PERMIT

SEWAGE DISPOSAL SYSTEM

HOWARD COUNTY HEALTH DEPARTMENT BUREAU OF ENVIRONMENTAL HEALTH ISSUE DATE _5/23/2001

Hatfield's Equipment	IS PERMITTED TO INSTALL X ALTER		
ADDRESS 13785 Burntwoods Road, Glenelg, MI			
SUBDIVISION <u>Cattail Ridge</u> LOTI	NUMBER 28 ADDRESS 3509 Winding Path Court		
PROPERTY OWNERSyndacom Property	PROPERTY OWNER'S ADDRESS 8808 Center Park Driv		
SEPTIC TANK CAPACITY 1250 GALLONS - 1	TOP SEAMED REQUIRED Columbia, MD 21045		
PUMP CHAMBER CAPACITY N/A GALLONS	S COTUMBIA, MD 21045		
NUMBER OF BEDROOMS4_			
SQUARE FEET PER BEDROOM210			
LINEAR FEET OF TRENCH REQUIRED280			
ZNOTTILE CONTINUE ZNOTTILE ZNO			
RENCHES: Trenches to be 3.0 feet wide. Inlet 2	2.0 feet below original grade. Bottom maximum depth

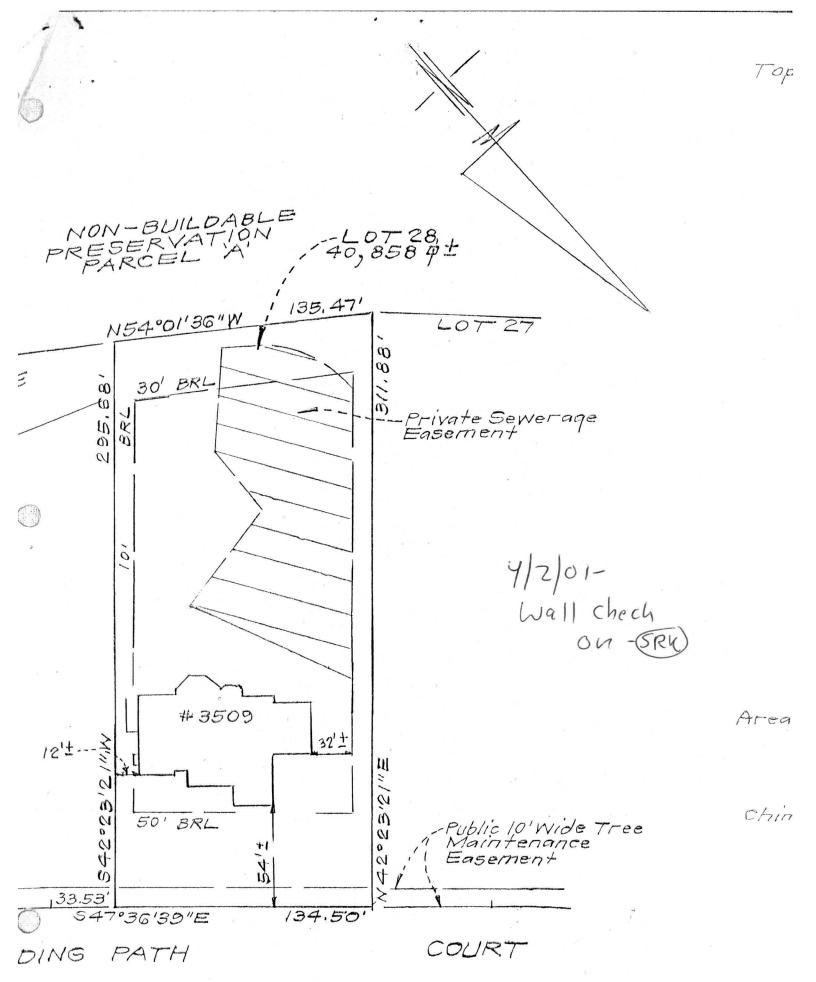
installed as per BP plan. To make gravity to system trunches will

INSPECTION COMMENTS: have to be deeper. There was a spotty rock problem

throughout subdivision. If a perc hole dug in the middle of the

trench area is OK to 10', then trenches may have a depth of 6'. No

deeper than 6' BB 6/1/01 Fest hole contained 750 To rock from 4'

To 9.5' BB 6/1/01 Trenches installed while inspector on site to

make sure perforated pipe was not used where hedrock was

encountered. Septic Pump test needed A super holes in Ahron & pump
